Job Ref: 7505 Downshire Hill 9

## **Detail Development Report**

[Please read with Britannia 'Belvedere Comparison' 7505/15.01.19 Drawings appended] 'Belvedere Detail' 7505/15.01.19

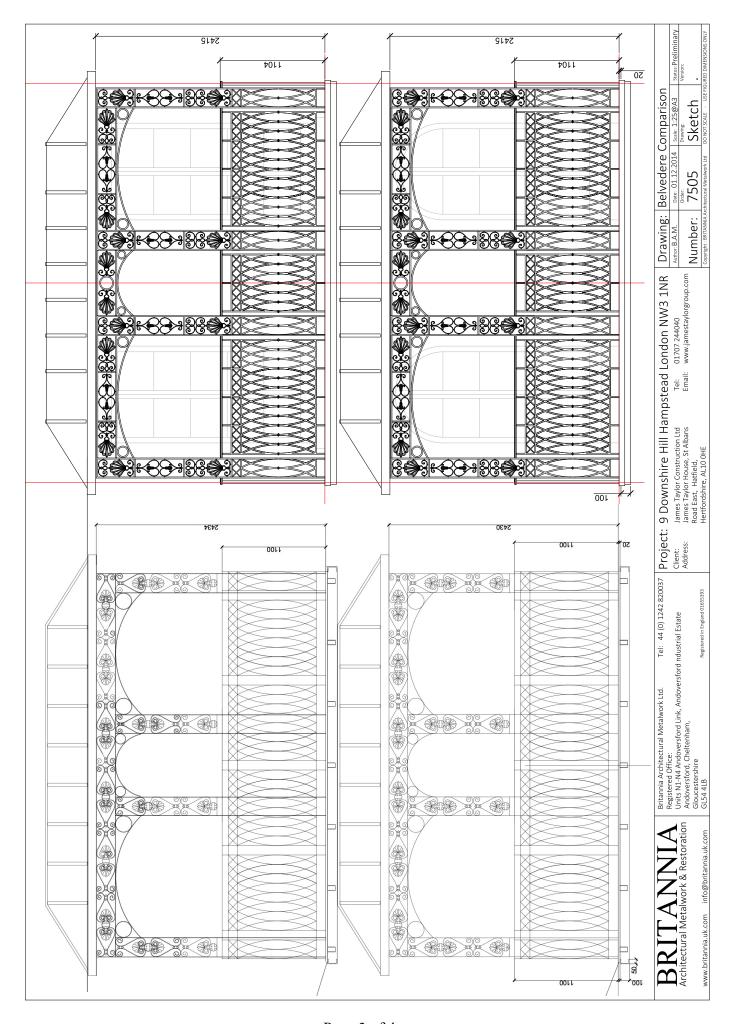
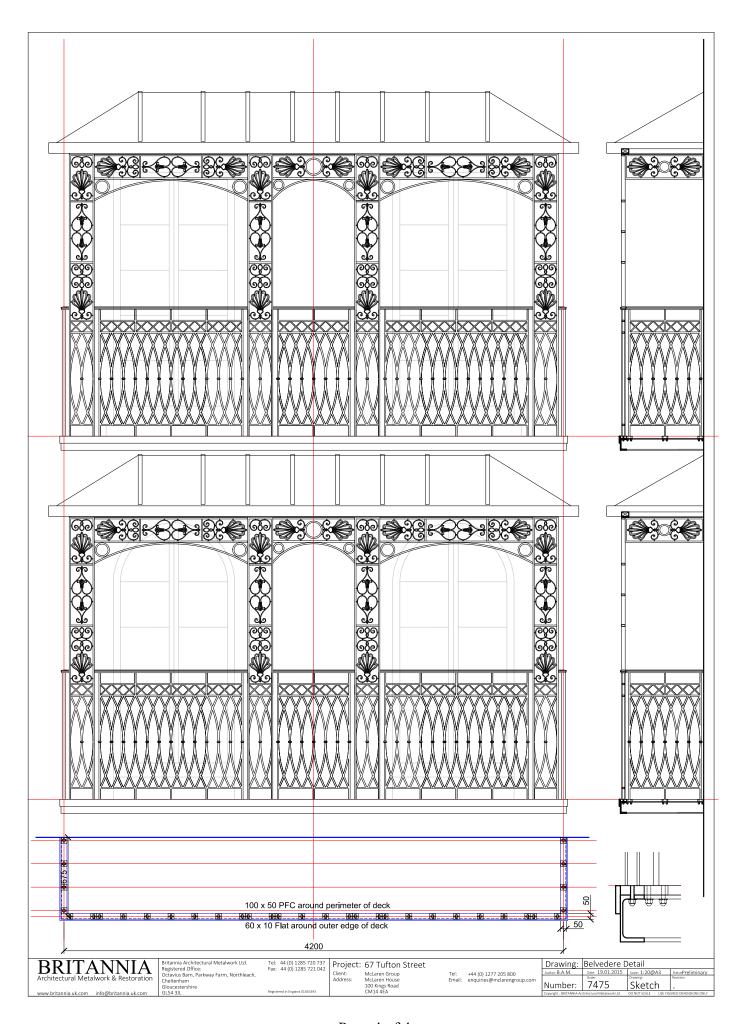
- i. Due to the necessary structural depth of the Belvedere pilasters and the balustrade panels, our proposal is to set the two element side by side and in the same plane as each other, rather than one behind the other as implied by the *Approved* drawing. This 'single plane' arrangement is by far the most common arrangement for these types of structures and avoids the unfortunate overlapping of elements shown on the *Approved* drawing, resulting in a visually lighter and more resolved and considered appearance.

- ii. In order that the Belvedere pilasters are able to have continuous vertical members which is a structural requirement we have altered the rhythm of the balustrade panels. In our view, this arrangement not only works structurally, but better expresses the architectural arrangement of the fenestration behind, with the balustrade panels directly reflecting the French windowsthat let on to the Belvedere

- i. The sand-cast decorative elements forming part of the belvedere pilasters and eaves beams are proposed to be arranged in a more ordered pattern than proposed in the *Approved* design drawing, more closely reflecting the modular appearance characteristic of these types of structure
- We respectfully submit that the above design and fabrication developments do not constitute a change of any significance to the design and that in all other respects the proposal remains faithful to the *Approved* design drawing.
